CARBON COUNTY PLANNING/SANITARIAN'S OFFICE
 P.O. BOX 466
 RED LODGE, MT 59068
 406-446-1694

RE: CREEKSIDE ESTATES AT REMINGTON RANCH
LOT 7B
CARBON COUNTY
E.Q. #98-1551

REVISED LOT LAYOUT OF CREEKSIDE ESTATES AT REMINGTON RANCH

August 19, 1999

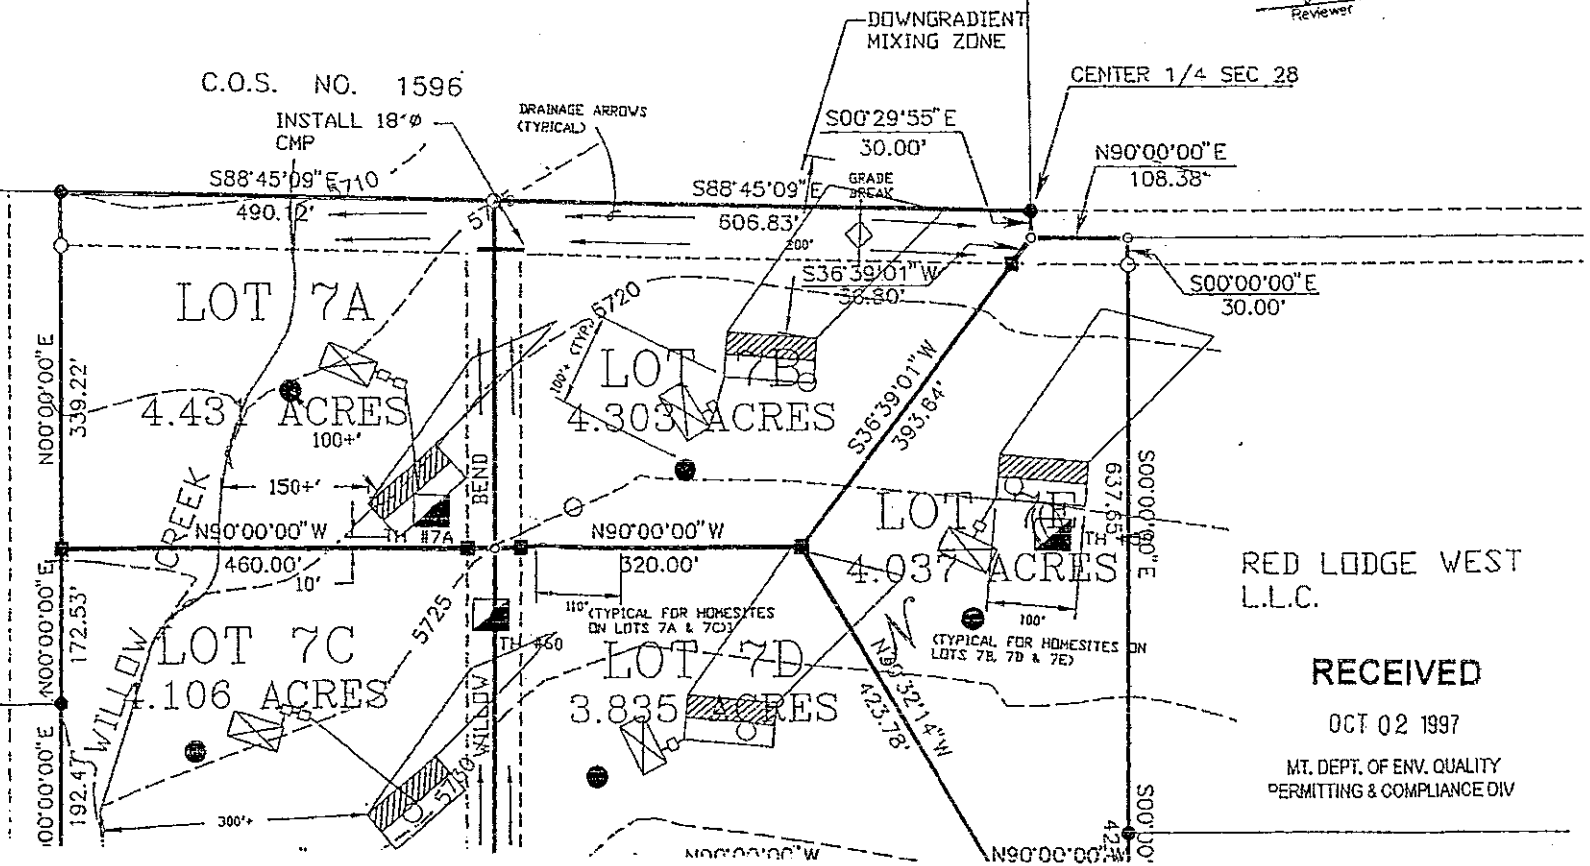
APPROVED
Montana Department of
Environmental Quality
Permitting and Compliance Division
LMH 10/19/97
Reviewer Date
